**AGENDA
CITY OF CEDAR FALLS, IOWA
PLANNING AND ZONING COMMISSION MEETING
WEDNESDAY, NOVEMBER 28, 2018
5:30 PM AT CITY HALL**

TO: Planning and Zoning Commission
FROM: Iris Lehmann, Planner I
DATE: November 20, 2018
SUBJECT: Design review of a property in the Central Business District Overlay

TO: Planning and Zoning Commission
FROM: Shane Graham, Planner II
DATE: November 20, 2018
SUBJECT: PC-2 District Site Plan Review – 936 Viking Road

TO: Planning & Zoning Commission
FROM: David Sturch, Planner III
DATE: November 20, 2018
SUBJECT: College Hill Neighborhood Site Plan Review – 2119 College Street

Proposed storefront

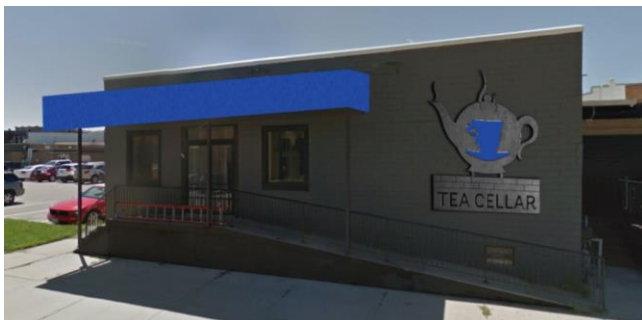
5. Window and transparency: The size, proportion and type of windows on the building are not changing. This criterion does not apply.
6. Materials and texture: The applicant is proposing to wrap a 2 foot wide blue "awning skirt" around the existing metal/wood awning on the storefront as well as add awnings over the four windows facing the neighboring parking lot to the south. The applicant will use a blue outdoor fabric for these improvements. The use of outdoor fabric is consistent with other awning materials in the district. This criterion is met.

7. Color: The colors of the exterior walls and roof of the building will not change. The applicant is proposing to use a blue fabric for the awnings that will act as an accent to the building. This criterion is met.

9. Building Entries: The entry to the building will not change. This criterion does not apply.
10. Exterior mural wall drawings, painted artwork, exterior painting. This criterion does not apply for this review
11. Signage: The applicant is proposing to add a wall sign to the storefront. The sign will be a laser cut-out of 12 gauge cold-rolled steel with a clear seal coat to help prevent rusting. The wall sign will be approximately 4 feet wide and 6 feet high (24 sqft). The sign will not detract from the architectural features of the building and will cover approximately 2% of the storefront. Wall signs are not permitted to exceed 10% of the area of the storefront. The area of the 209 State Street storefront is approximately 1,035 sqft (69 feet wide x 15 feet tall). This criterion is met.

Building Height Comparisons

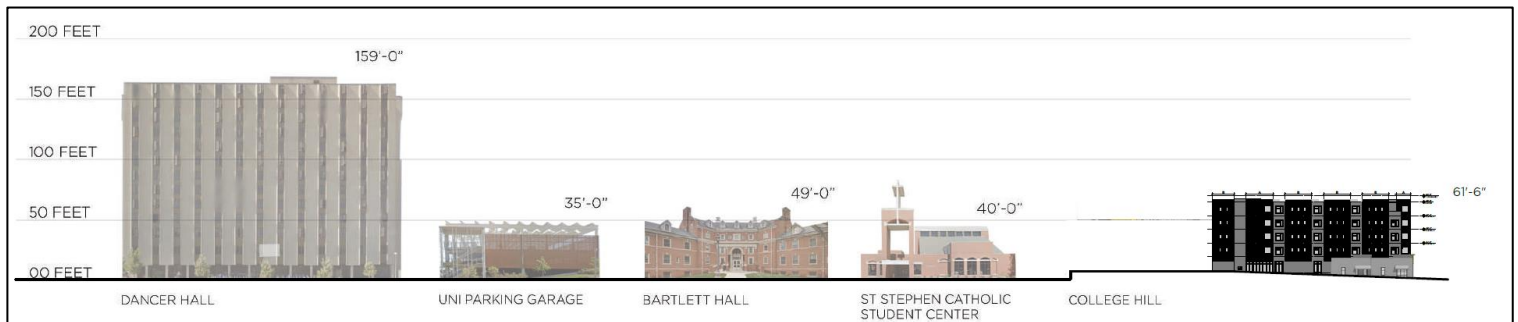
The applicant has provided a diagram which shows several other buildings within a 2-3 block area that are taller than the proposed building (see attached diagram for building locations). In the diagram, it shows the proposed building with a height of approximately 62 feet. Other buildings in the area and their heights include the St. Stephen Catholic Student Center on W 23rd Street at 40 feet in height, Bartlett Hall on the UNI campus on W 23rd Street at 49 feet in height, the UNI parking garage on W 23rd Street at 35 feet in height, and Dancer Hall on Campus Street on the UNI campus at 159 feet in height. Also, the applicant has provided a side elevation diagram which shows the street section of buildings located on College Street and their height comparison to the proposed building. Based on the diagrams presented below, staff feels that the building scale and height will not be out of character for the area, as there are other structures within the neighborhood that are comparable in scale and height to the proposed building.

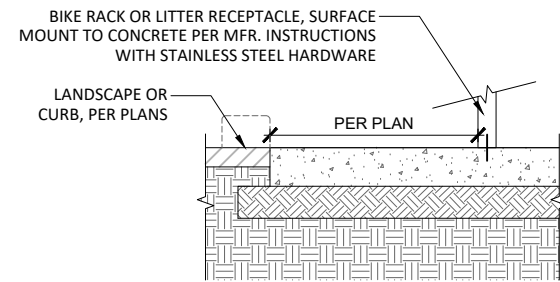
12) Bike Racks: There are 2 bike racks located on College Street next to the tree grates. These are a black powder coated rack for five bikes. Additional bike racks should be placed behind the building next to the parking lot. **Add more bike racks by the back entrance into the building.**

- 1) Any additional comments or direction specified by the Planning & Zoning Commission.
- 2) Add additional bike racks near the back entrance of the building by the parking lot.

COLLEGE HILL TRASH ENCLOSURE

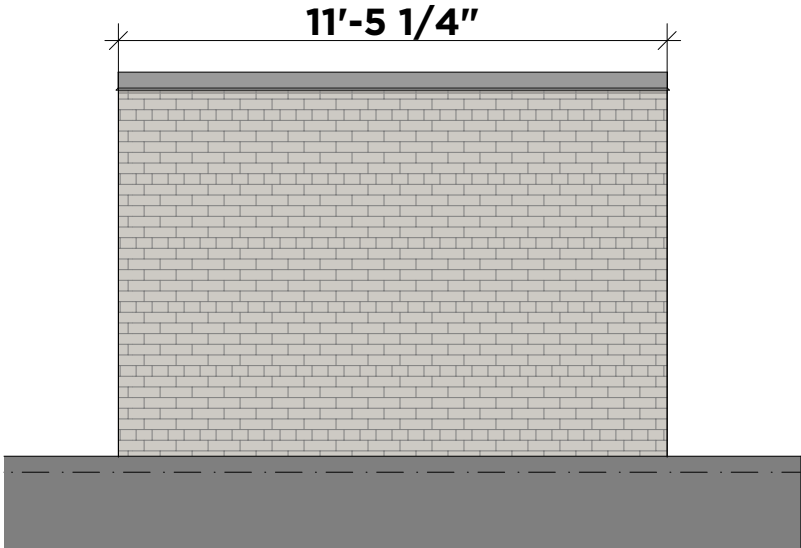
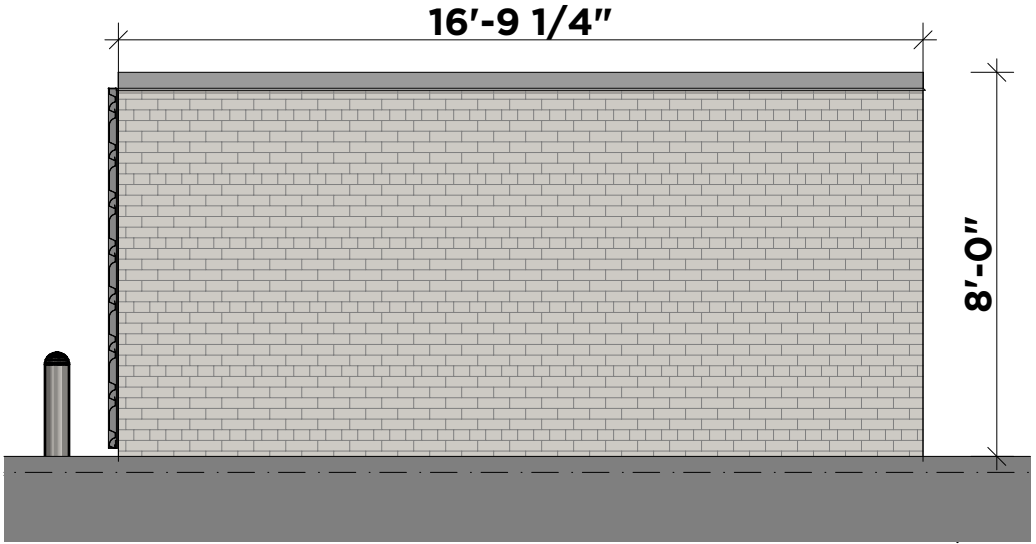
8) Trash Dumpster Site: The site plan shows a dumpster enclosure contained within the parking area at the northwest corner of the lot. The 8'-0" tall trash enclosure is constructed with a brick wall to match the building with metal doors. The landscaping plan shows trees, shrubs and ornamental grasses along the north and west side of the enclosure. **Trash enclosure is acceptable.**
